Form 3160-5
(August 2007)UNITED STATES
DEPARTMENT OF THE INTERIOR
BUREAU OF LAND MANAGEMENTOCD Hobbs
SEP 19 2011FORM APPROVED
OMB No 1004-0137
Expires July 31, 2010**SUNDRY NOTICES AND REPORTS ON WELLS**
Do not use this form for proposals to drill or to re-enter an abandoned well. Use Form 3160-3 (APD) for such proposals.

MESA VERDE 15 FED #1

30-025-36836

**September 14, 2011
Conditions of Approval**

PROPOSED

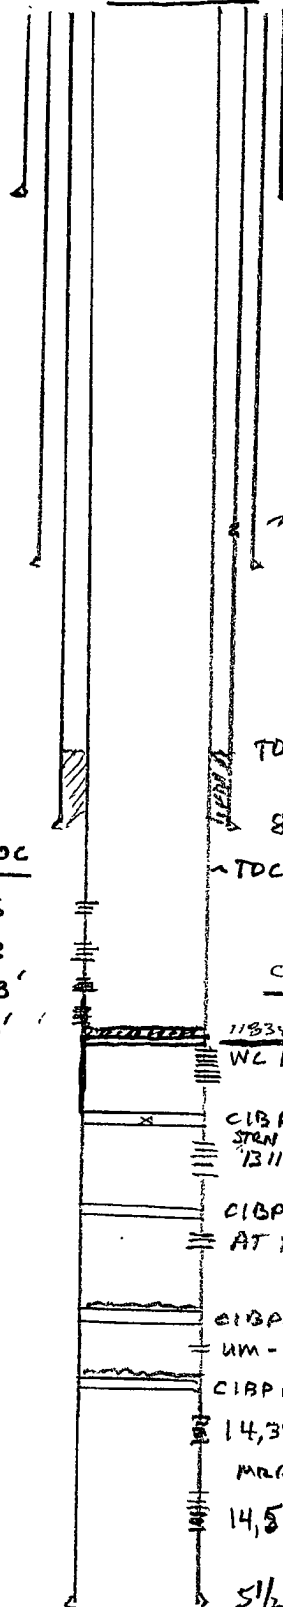
This Sundry Notice is to modify existing Sundry Notice dated 07/22/2011 in the following ways:

- 1 eliminate additional Wolfcamp perms
- 2 temporarily abandon the current Wolfcamp perms
- 3 recomplete in Bone Springs, to test

3rd Bone Springs 11,648' - 11,796', 2nd Bone Springs 10,892' - 11,328', 2nd Bone Springs 9,951' - 10,088', Avalon 9,026' - 9,215'
The CIBP set @ 13,100' will remain, however dump 35' cmt on top of plug
